# Rezoning Transportation Analysis

Petition Number: 2019-115

**From:** Felix Obregon, PE  
[fobregon@charlottenc.gov](mailto:fobregon@charlottenc.gov)  
704-432-5729

Revision Log:	Date	Description
	09-29-2019	First Review
	11-15-19	Second Review
	1-9-2020	Third Review
	1-31-2020	Fourth Review

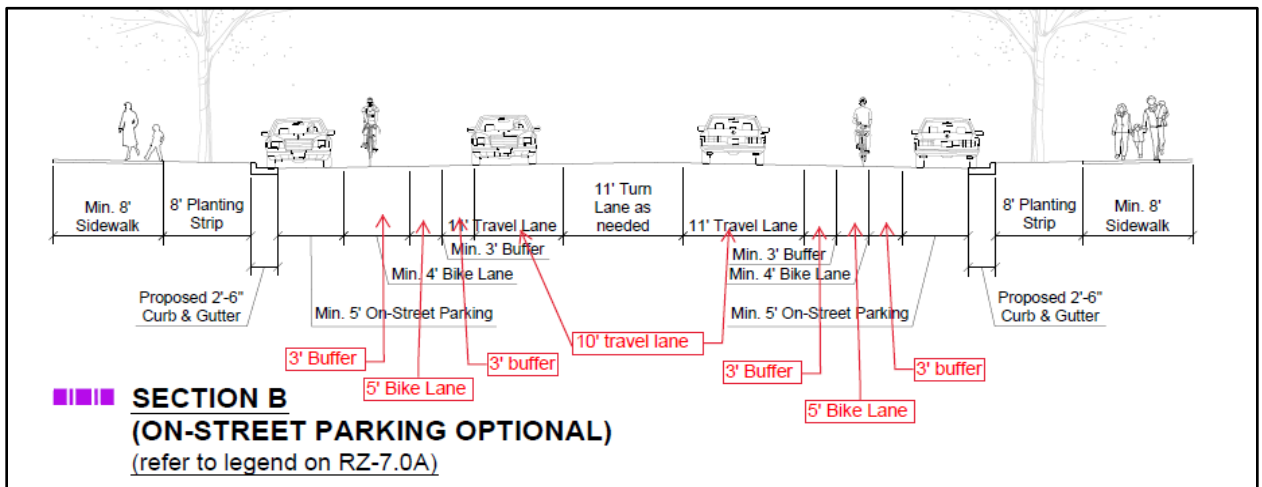
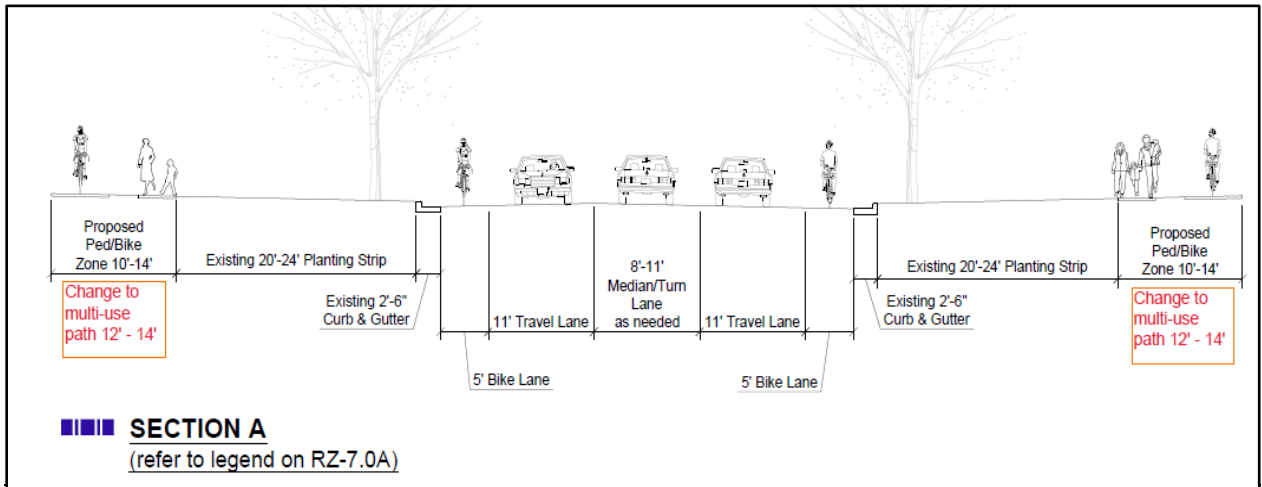
5. ~~Revised comment based on revised site plan (10/16/19):~~ The petitioner should revise the site plan on Sheet RZ-7.0B and conditional notes to show the proposed cross-section for Ballantyne Corporate Place incorporating the future light rail alignment. The petitioner should include language committing to dedicating and/or reserving 120' of right-of-way for the future light rail (see the below conceptual street/light rail cross section on Ballantyne Corporate Place).

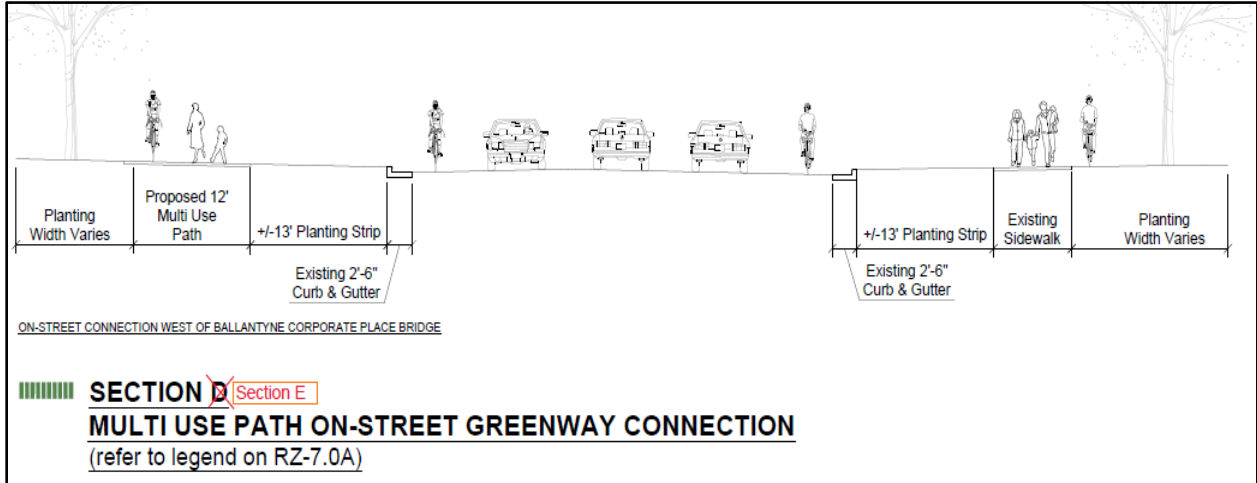
13. Sheet RZ-7.0B shows 2 "Section D" cross-sections and conflict with the street network on Sheet RZ-7.0A. The petitioner should revise the site plan showing the correct matching cross-sections between Sheets RZ-7.0A and RZ-7.0B.

a. ~~Comment Clarification Based on Revised Site Plan (10/16/19):~~ Section D cross section in Sheet RZ7.0B should be labeled Section "E" to match the site plan in Sheet RZ 7.0A.

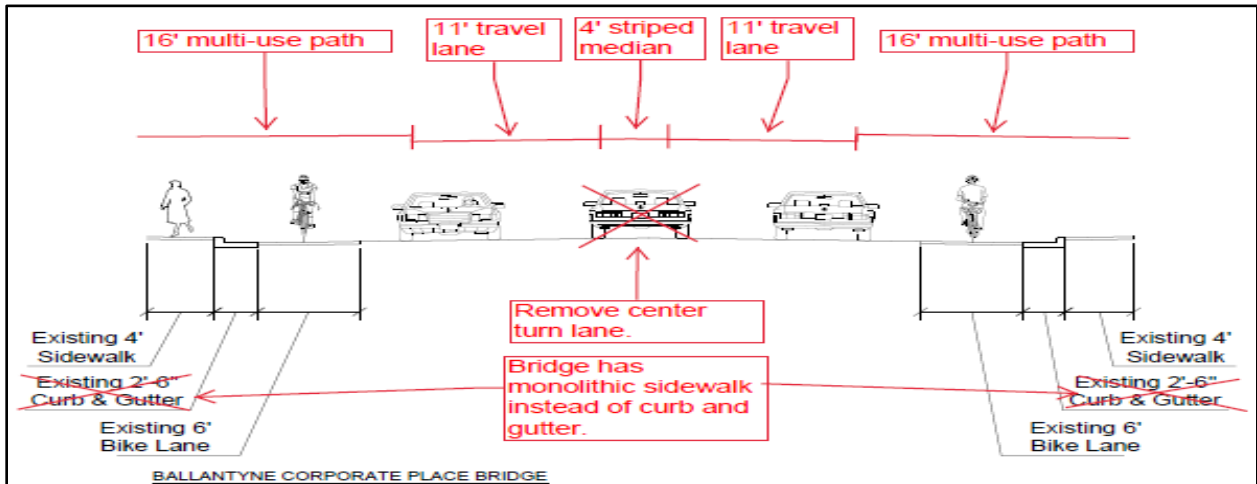
14. The petitioner should revise the site plan and conditional notes to commit to reallocating space on Ballantyne Corporate Place bridge over Johnston Road/521 to be 2 travel lanes, buffered bike lanes, and 8.5' sidewalks.

a. ~~Comment Clarification Based on Revised Site Plan (10/16/19):~~ The Ballantyne Corporate Place bridge cross-section as depicted on RZ-7. OB should be updated to reflect the comments provided below. Furthermore, the total width on the cross-section shown on the rezoning plan does not match the existing width of the bridge. The petitioner should verify the correct width of the bridge is shown accurately on the rezoning plan.
